LETTER REGARDING REGULATORY REVIEW AND COMMENTS ON DRAFT FINAL
REMEDIAL INVESTIGATION FEASIBILITY STUDY WORK PLAN NCBC GULFPORT MS
3/15/1993
MISSISSIPPI DEPARTMENT OF ENVIRONMENTAL QUALITY

Re: Draft Final RI/FS Work Plan
Naval Construction Battalion Center
Gulfport, MS

Mississippi DEQ Comments
RI/FS Work Plan
Naval Construction Battalion Center
Gulfport, MS

Phase II
COMMENTS FOR THE FINAL VERIFICATION REPORT
NAVAL CONSTRUCTION BATTALION CENTER (NCBC)
GULFPORT, MISSISSIPPI

GROUNDWATER MONITORING WELL AND SAMPLING LOCATIONS - SITE 6
NCBC Gulfport
Gulfport, Mississippi

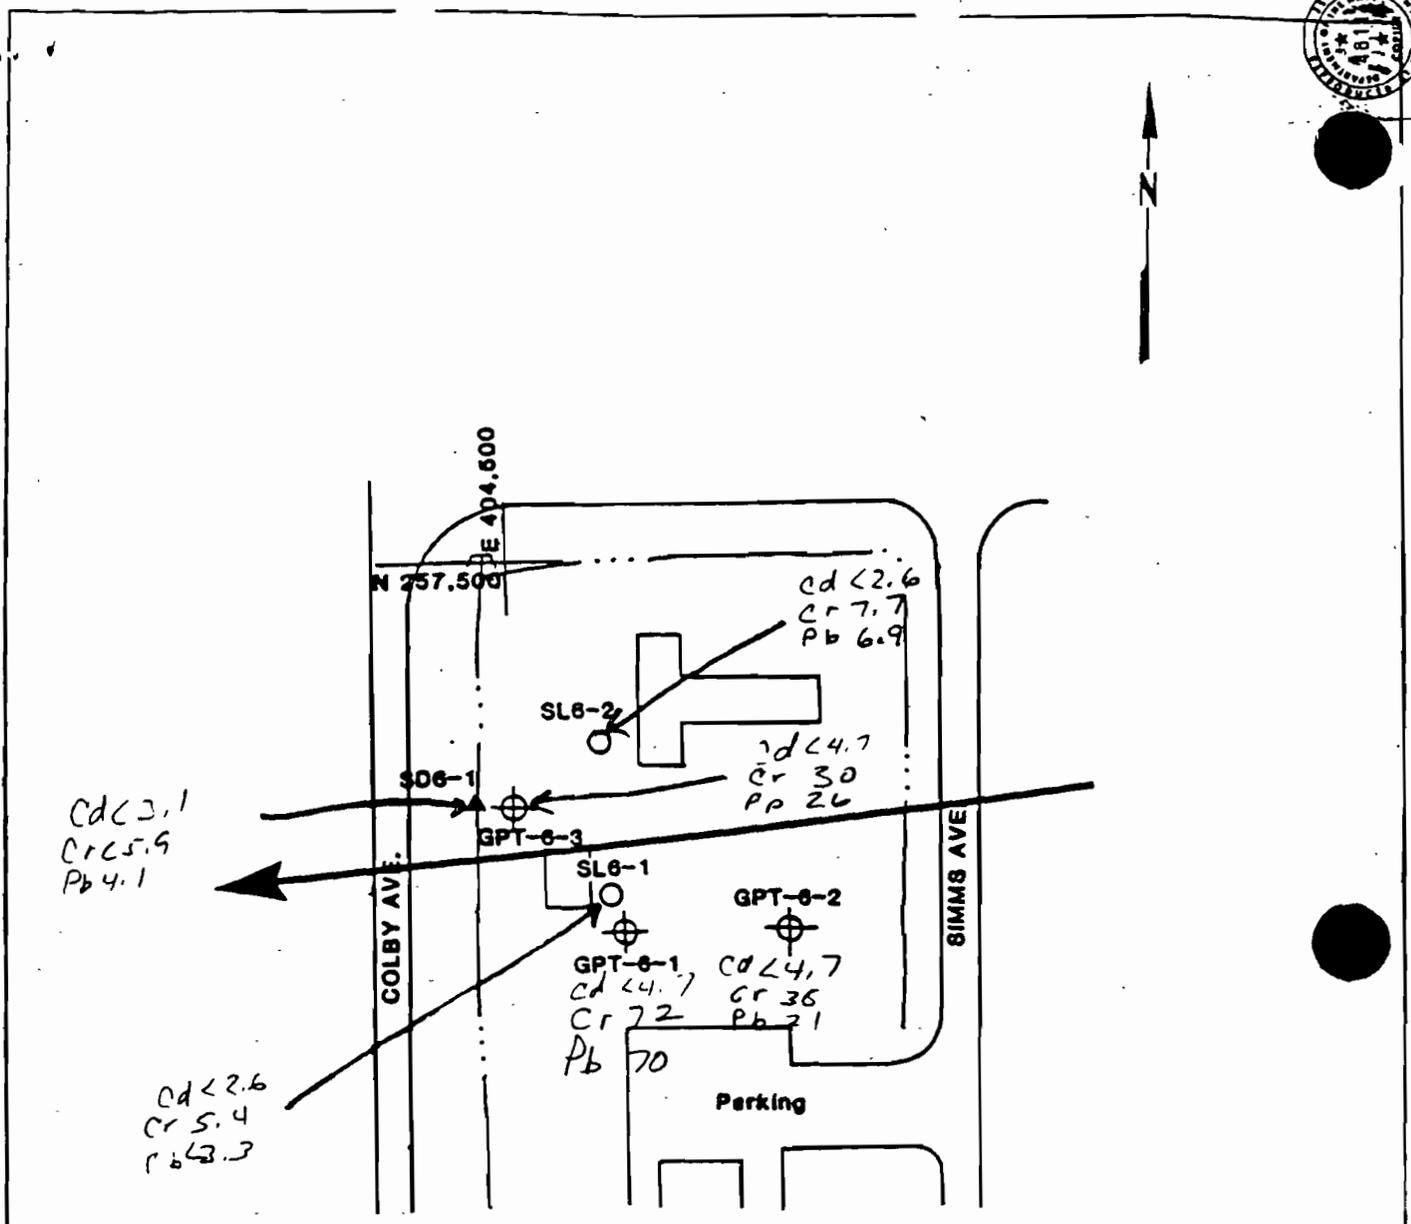
The concerns at Site 6 are much the same as those at Sites 4 and 5 (figure 8). Concentrations of chromium and lead in GPT-6-1 are 72 ppb and 70 ppb, respectively. Levels of these two metals are below the MCL of 50 ppb in each of the other two monitoring wells, but they are high enough to be of concern. As stated previously, sampling of discrete intervals is recommended to confirm the level of contamination and to determine if there is vertical variations in their concentrations.

The disposal of MEK at this site makes it necessary that it be included in the list of chemical constituents analyzed for in future sampling events.
